Kentec Electronics Ltd.

Loop Explorer V6.00 Update Information

The following list details the changes made to Loop Explorer V6.00 and the reasons these were introduced.

Automatic Sounder Resound operation

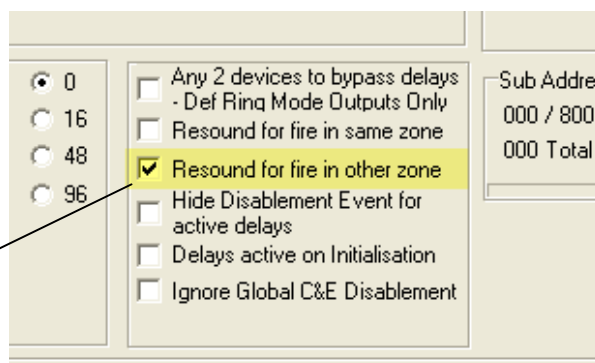
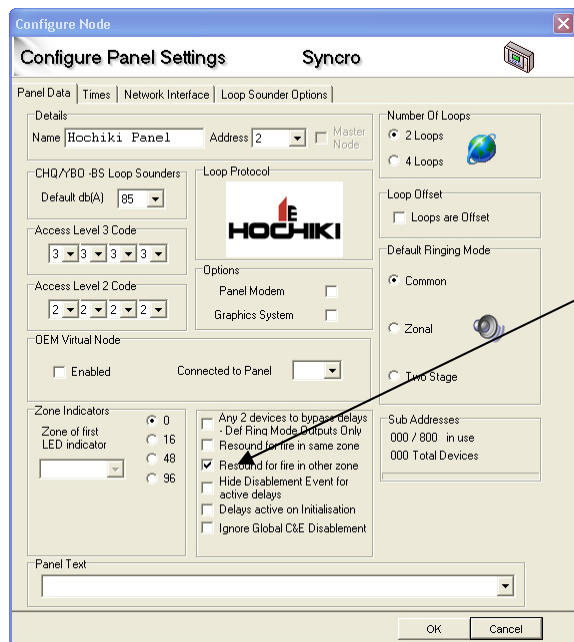
Due to EN54-2 Amendments A1 and A2 requirements, a revision to the Sounder "resound" operation has been introduced.

On older panels, when there is a fire in a zone and the sounders are silenced, the sounders will automatically re-sound for a fire in another zone.

The requirement of EN54-2 A1/A2 requires that it is possible to configure the panel so the sounders do not resound for a fire in another zone. There is now a configuration option in loop explorer "Edit Panel Settings" screen to allow this selection.

This revision only applies to panels with V6.00 or later firmware

Zone disablements for Loop Input/Output devices

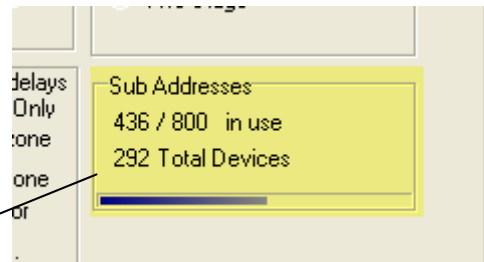
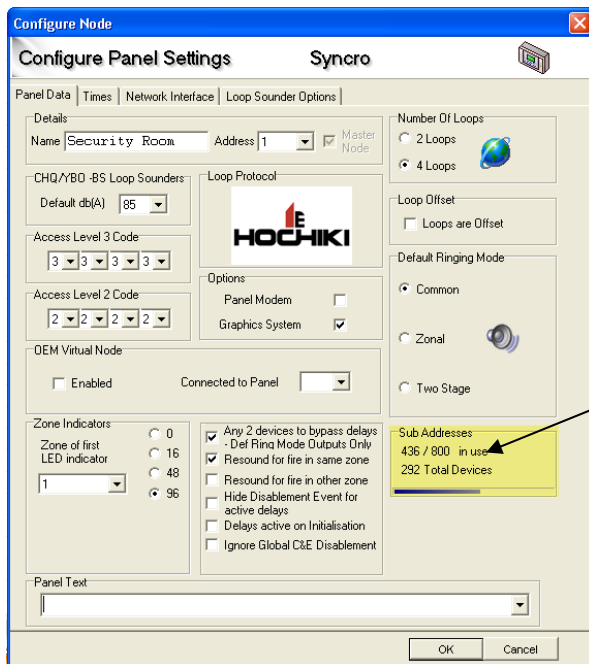
For Loop I/O devices, when the zone that the physical module address is mapped to has been disabled, then ALL inputs / outputs associated with that module would be disabled, regardless of whether the input sub-addresses are mapped to the same zone as the physical module.

It is now possible to configure a loop I/O device so that when the physical module address and input / output addresses are mapped to different zones, there is an option to configure whether all sub-address inputs/outputs will be disabled with the zone of the module or not.

Option to include/exclude module inputs / outputs in the module zone disablement

Option to include output sub-addresses in the zone disablement to which they are configured

When a zone is disabled, normally only input devices are included in the disablement and outputs remain active. We have added an option to permit I/O outputs to be included in the zone disablement to which they are configured

Finally, if the Inputs/ Outputs are configured to be included in the module zone disablement (as shown above) and the inputs are configured to different zones to the module address zone, they can still be included / excluded in the module zone disablement.

Option to include inputs in the module zone disablement

We have partially re-instated this facility using these configuration options

Note: This revision only applies to V6.00 or later panel firmware

Discovery Sounder Beacon Base (DSBB) - Beacon configuration

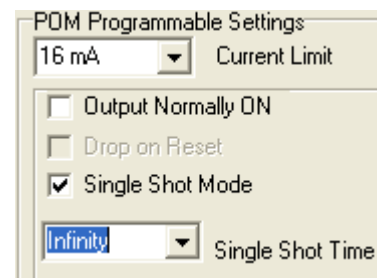
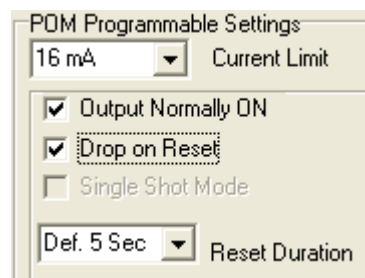
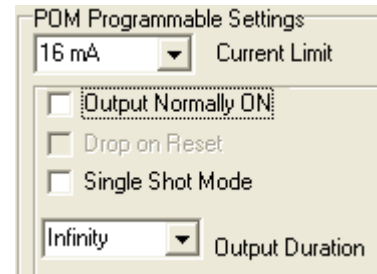
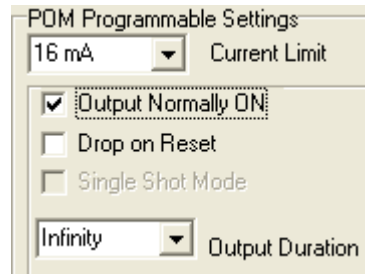
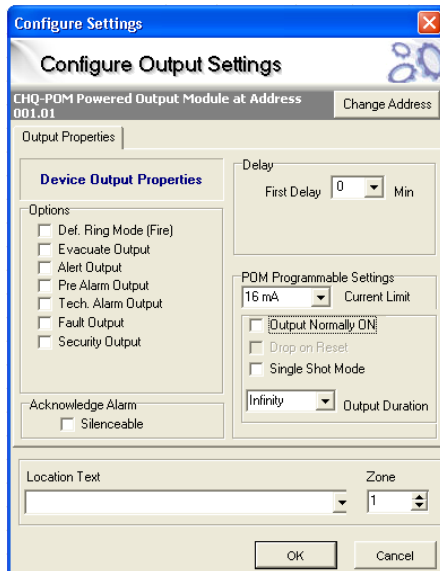
The DSBB beacon sub-address cannot be independently controlled if the DSBB has been switched using the "common event" controls detailed above. Configuration restrictions to only allow the beacon to be independently controlled from the sounder if the sounder is not controlled by a common event tone (i.e if the sounder is being controlled by Zonal / 2 stage def ring mode, delayed operation or by cause and effect) have been added.

The beacon will follow the sounder settings when the panel is in Common Mode with Def. Ring set. The beacon settings are available if the panel is in Zonal / 2 Stage mode or the device has delayed operation or Def. Ring is not set on the sounder.

V200 Multi Criteria Monitor – Extended Modes

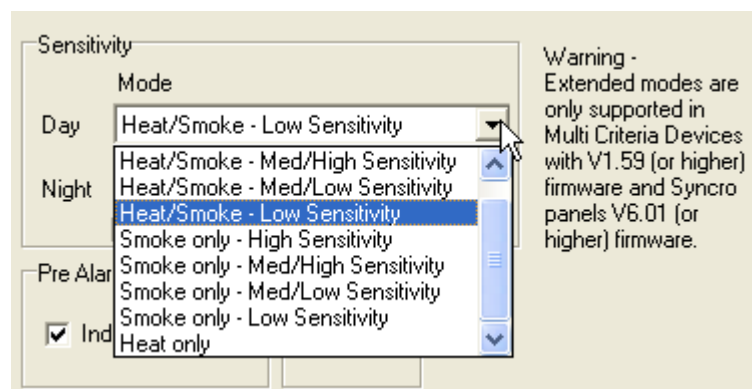
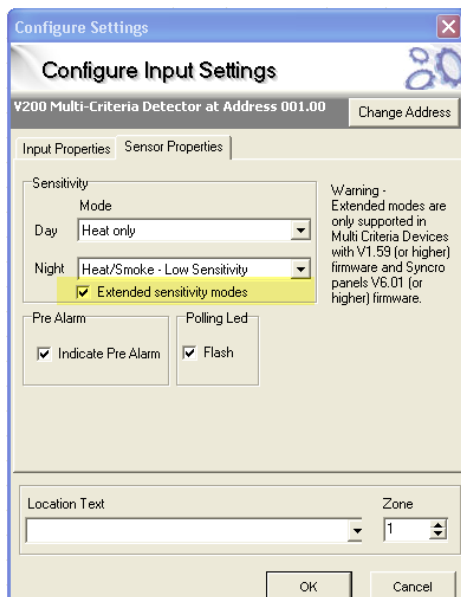
This device can now be configured to operate as multi criteria mode (4 sensitivity settings), optical mode only (4 sensitivity settings) or heat only mode (1 setting). This is only supported by V200 devices with firmware V1.59 or later and Syncro V6.01 or later.

The sensitivity mode options have been revised from Mode 1 – Mode 4 to High, Medium High, Medium Low and Low. The default setting is set to Low
